**Re: Nogales Transmission, L.L.C. – Nogales Interconnection Project – PP 420  
Application Amendment**

This letter amends the April 8, 2016, Application for a Presidential Permit for the Nogales Interconnection Project (the “Project”).

### **Project Configuration Diagrams**

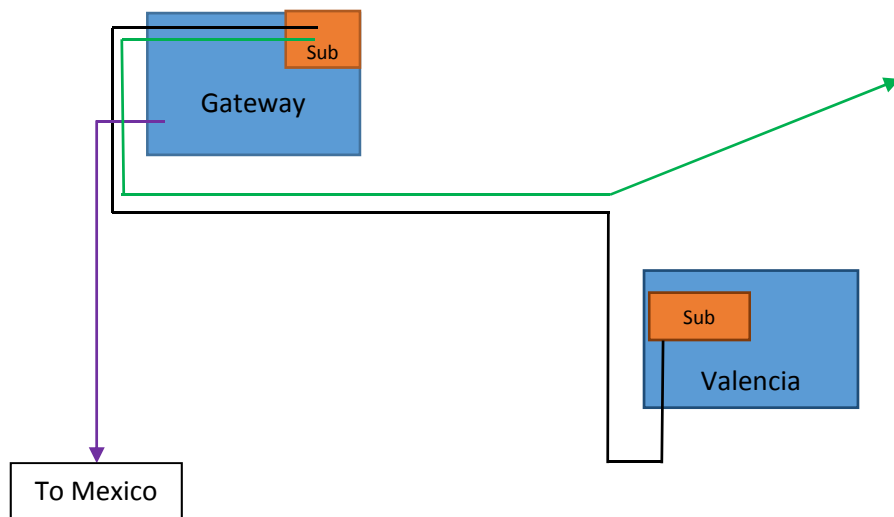
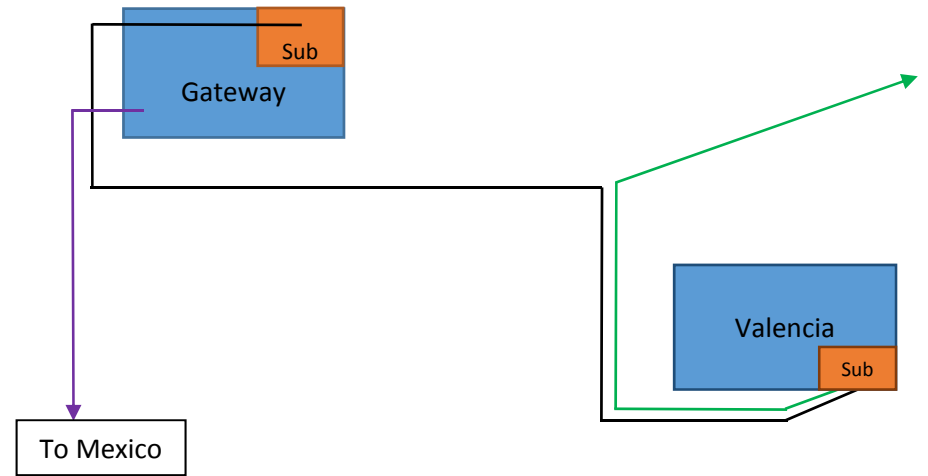
This amendment reflects an electrical reconfiguration that has been designed to make the Project more cost-effective. Conceptually, the new configuration connects the Project to the UNS Electric (“UNSE”) system at the planned Gateway Substation (“Gateway”) rather than, as originally proposed, at the existing Valencia Substation (“Valencia”). As discussed in more detail below, that connection will be accomplished by severing the existing UNSE Vail to Valencia 138-kV line and connecting it to one circuit of a new double-circuit 138-kV line, to be constructed and owned by UNSE, with an origination point near Valencia and a termination point at Gateway. A second circuit on that line will originate at Gateway and terminate at an existing UNSE line near Valencia; that circuit will serve as the source for Valencia. These changes are illustrated conceptually on Attachment 1, and the specific changes are detailed below. The reconfiguration does not change the proposed Project route or right-of-way requirements set forth in the Application, and as compared to the original configuration would have equal or better reliability.

The reconfiguration would connect the Project to the UNSE transmission system at Gateway rather than at Valencia. A new, approximately 3-mile long, overhead double-circuit 138-kilovolt (kV) alternating current (AC) transmission line would be constructed on new double-circuit monopoles. The first circuit will originate at an existing pole 1,900 feet west of the existing Valencia Substation and terminate at the new Gateway Substation. At the origination point, the existing Vail to Valencia line will be severed and connected to this new line, thereby converting the existing Vail to Valencia transmission line to the “Vail to Gateway” transmission line. The second circuit will originate at the Gateway Substation and proceed in an easterly direction to a pole 1,900 feet west of the existing Valencia Substation, where it will connect with the existing portion of the UNSE 138-kV transmission line that travels east along the north side of W. White Park Drive to the Valencia Substation. This circuit will constitute the new “Gateway to Valencia” transmission line. The reconfiguration is shown on a map at Attachment 2, and a one-line diagram of the reconfiguration is provided at Attachment 3.

**Project One-Line Diagram**

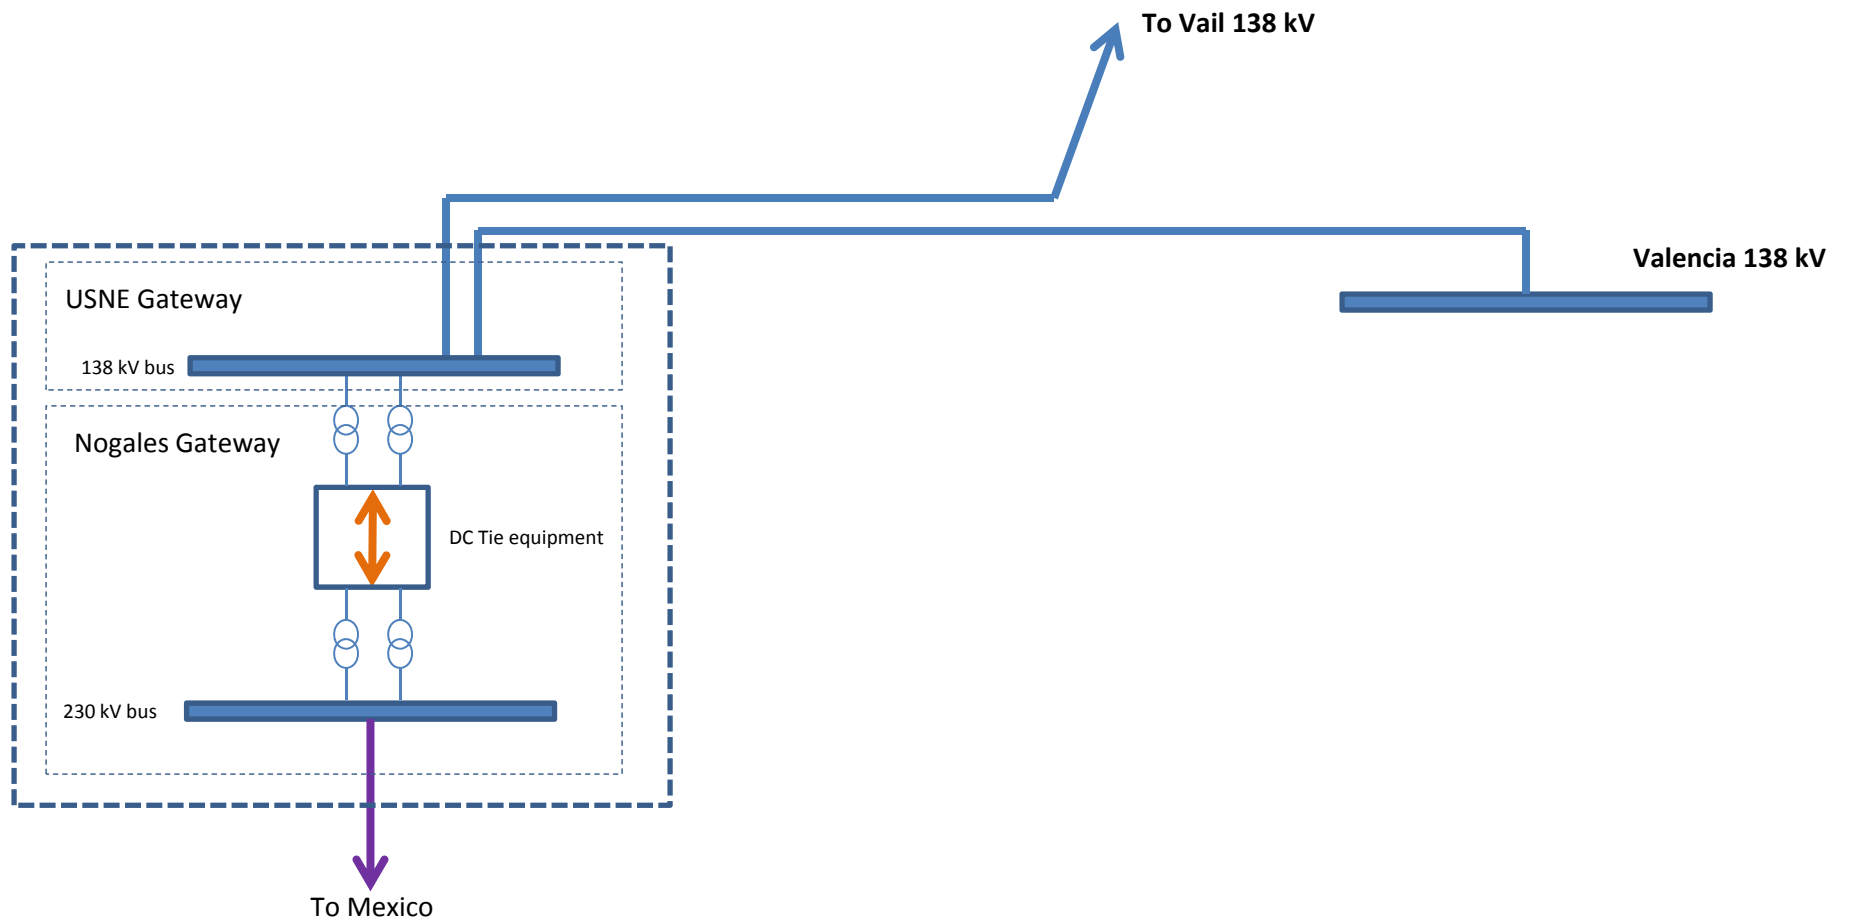
Under the new configuration, there will be only minor modifications relating to relaying equipment at the existing UNSE Valencia Substation; those modifications are necessary to accommodate the connection from the proposed 138-kV transmission line from Gateway to Valencia. Because the UNSE transmission line will now terminate at Gateway, in addition to the Gateway Substation envisioned in the original Application, a new approximately 1.8-acre UNSE 138-kV Gateway Substation will be constructed on the eastern edge of the Gateway site. This substation will consist of a three-bay, breaker and a half, open-air configuration that will accommodate the line from Vail, the line to Valencia, the connection to the DC converter and a future UNSE distribution transformer.

# Alternative 1 – Original vs Alternate Configuration

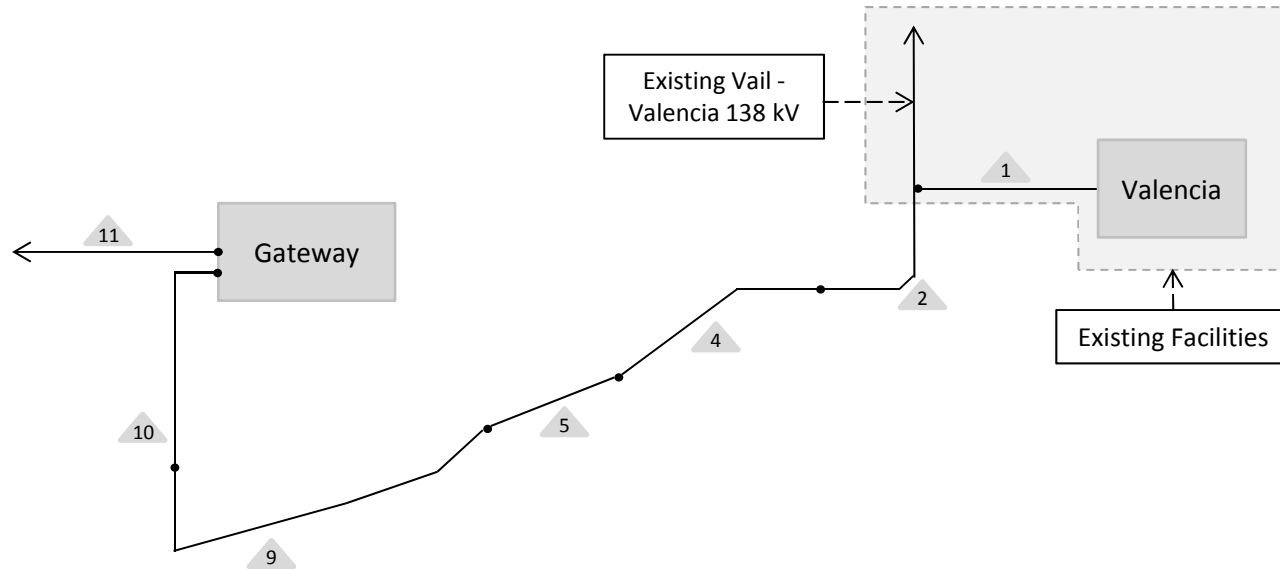
Segment	Original Configuration	Alternate Configuration
Valencia	Rebuild required	No rebuild required
1	Double-circuit 138kV on existing double-circuit poles	Single-circuit 138kV on existing double-circuit poles
2/4/5/9/10	Single-circuit 138kV on double-circuit poles	Double-circuit 138kV on double-circuit poles. Adding a second circuit does not impact pole height.
11/13/15	Single-circuit 230kV on double-circuit poles	No change
Gateway	Expansion and buildout	Same, with incremental 138kV facilities
ROW Width	150'	No change
ROW length	Approximately 5.8 miles	No change
Access Roads	3.08 miles of Access Type A and 0.24 mile of Access Type B, and require the upgrade of 3.22 miles of Access Type C roads. Additionally, 2.27 miles of Access Type D and 0.49 mile of Access Type E roads would be constructed.	No change

# Alternative 2 – Original vs Alternate Configuration

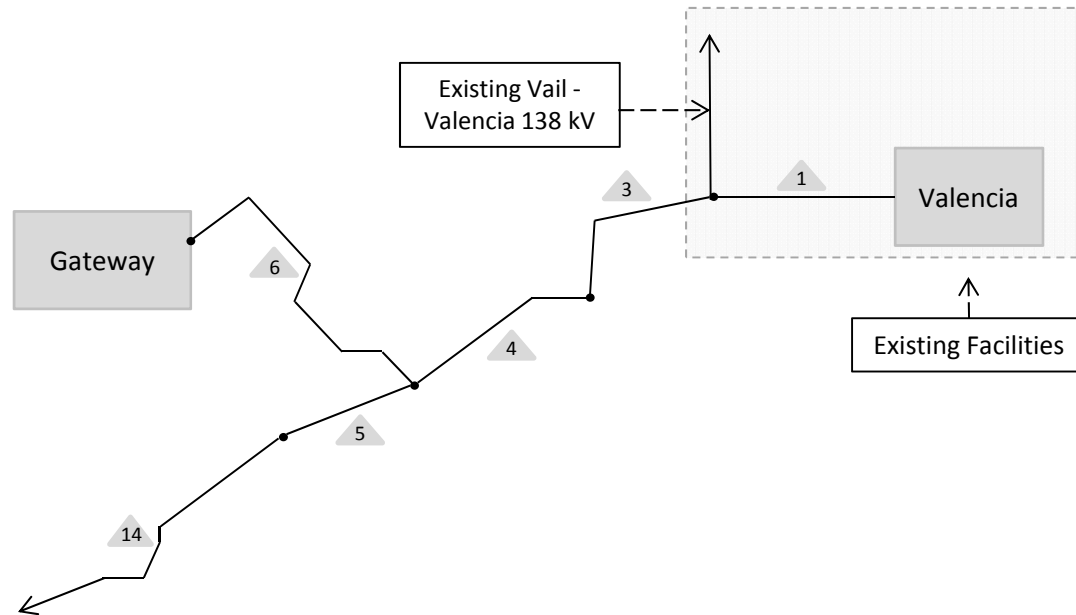
Segment	Original Configuration	Alternative Configuration
Valencia	Rebuild required	No rebuild required
1	Double-circuit 138kV on existing double-circuit poles	Single-circuit 138kV on existing double-circuit poles
3/4	Single-circuit 138kV on double-circuit poles	Double-circuit 138kV on double-circuit poles. Adding a second circuit does not impact pole height.
6	One circuit 230kV, one circuit 138kV on double-circuit poles; Seven poles with an average height of ~115 feet.	One circuit 230kV, two circuits 138kV on triple-circuit capable poles; Seven poles with an average height of ~140 feet.
5/14/15	Single-circuit 230kV on double-circuit poles	No change
Gateway	Expansion and buildout	Same, with incremental 138kV facilities
ROW Width	150'	No change
ROW length	Approximately 4.9 miles	No change
Access Roads	1.57 miles of Access Type A and 0.86 miles of Access Type B, and require the upgrade of 1.60 miles of Access Type C roads. Additionally, 2.00 miles of Access Type D and 0.38 mile of Access Type E roads would be constructed.	No change

# Alternative 3 – Original vs Alternate Configuration

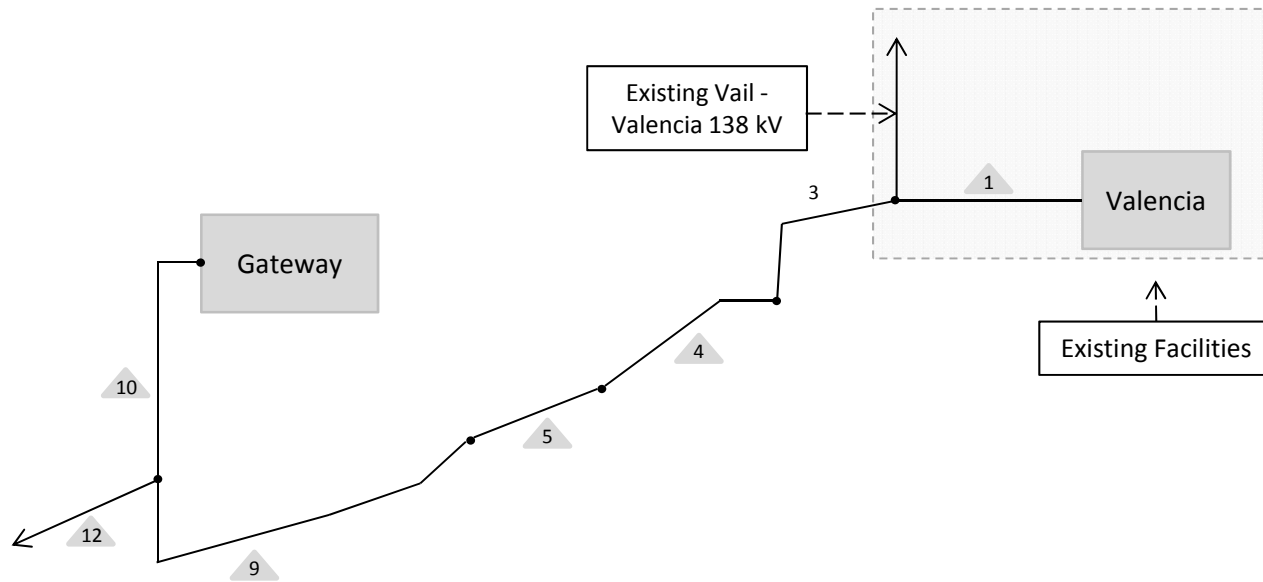
Segment	Original Configuration	Alternative Configuration
Valencia	Rebuild required	No rebuild required
1	Double-circuit 138kV on existing double-circuit poles	Single-circuit 138kV on existing double-circuit poles
3/4/5/9	Single-circuit 138kV on double-circuit poles	Double-circuit 138kV on double-circuit poles. Adding a second circuit does not impact pole height.
10	One circuit 230kV, one circuit 138kV on double-circuit poles; Five poles with an average height of ~110 feet.	Single-circuit 230kV on double-circuit poles, double-circuit 138kV on double-circuit poles; Twelve poles with an average height of ~100 feet.
12/13/15	Single-circuit 230kV on double-circuit poles	No change
Gateway	Expansion and buildout	Same, with incremental 138kV facilities
ROW Width	150'	No change
ROW length	Approximately 5.1 miles	No change
Access Roads	2.23 miles of Access Type A and 0.76 miles of Access Type B, and require the upgrade of 2.60 miles of Access Type C roads. Additionally, 1.97 miles of Access Type D and 0.26 mile of Access Type E roads would be constructed.	Same, with incremental 0.3 miles of Type E roads (spur roads).

# Alternative 4 – Original vs Alternate Configuration

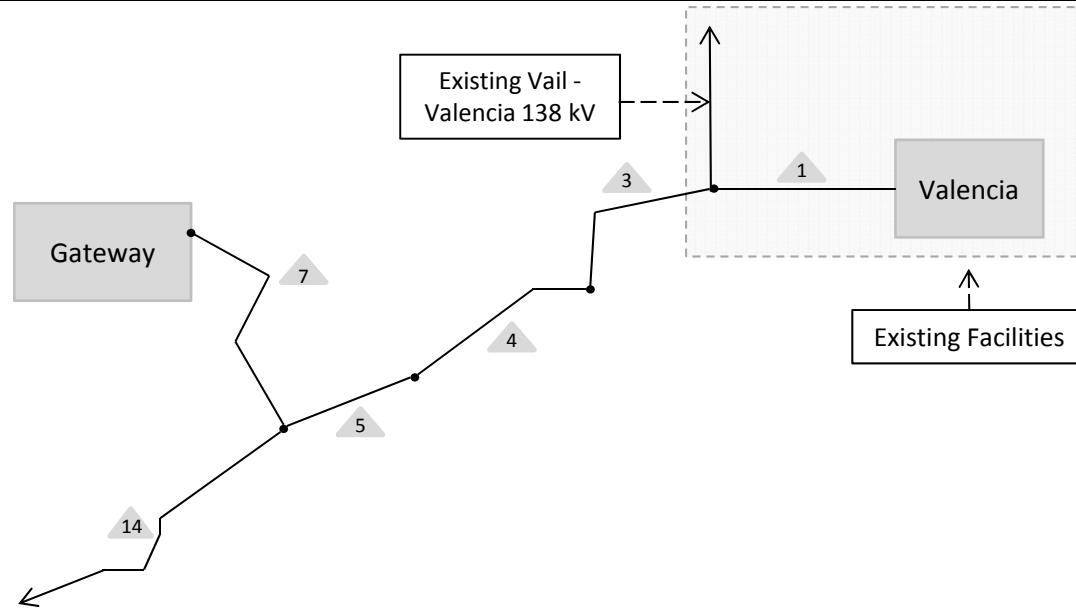
Segment	Original Configuration	Alternative Configuration
Valencia	Rebuild required	No rebuild required
1	Double-circuit 138kV on existing double-circuit poles	Single-circuit 138kV on existing double-circuit poles
3/4/5	Single-circuit 138kV on double-circuit poles	Double-circuit 138kV on double-circuit poles. Adding a second circuit does not impact pole height.
7	One circuit 230kV, one circuit 138kV on double-circuit poles; Five poles with an average height of ~115 feet.	Double-circuit 138kV line on double-circuit poles on one side of Mariposa Ranch Road and one 230 kV circuit line on double-circuit capable structures on the opposite side of Mariposa Ranch Road. Ten poles with an average height of ~105 feet.
14/15	Single-circuit 230kV on double-circuit poles	No change
Gateway	Expansion and buildout	Same, with incremental 138kV facilities
ROW Width	150'	No change
ROW length	Approximately 4.6 miles	No change

Access Roads	1.60 miles of Access Type A and 1.15 miles of Access Type B, and require the upgrade of 1.26 miles of Access Type C roads. Additionally, 2.04 miles of Access Type D and 0.26 mile of Access Type E roads would be constructed.	Same, with incremental 0.4 miles of Type E roads (spur roads).

### **Typical Tower Arrangement Diagrams**

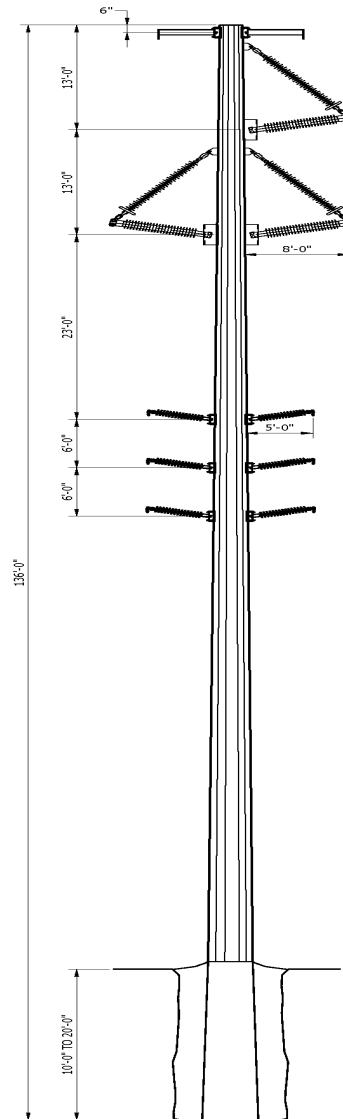
There would be changes to the tower configuration for route segments 6, 7 and 10. As noted above, route segment 6 would utilize a triple-circuit transmission line configuration, and route segments 7 and 10 would utilize double-circuit 138-kV transmission line and one 230-kV single-circuit on double-circuit capable structures in the same corridor. A conceptual arrangement for those tower configurations is provided at Attachment 5.

# Relevant for Alternative 2: Typical Arrangement of triple circuit capable poles within 150' ROW, Segment 6

# Relevant for Alternative 3: Typical Arrangement of 138 kV and 230 kV poles within 150' ROW, Segment 10
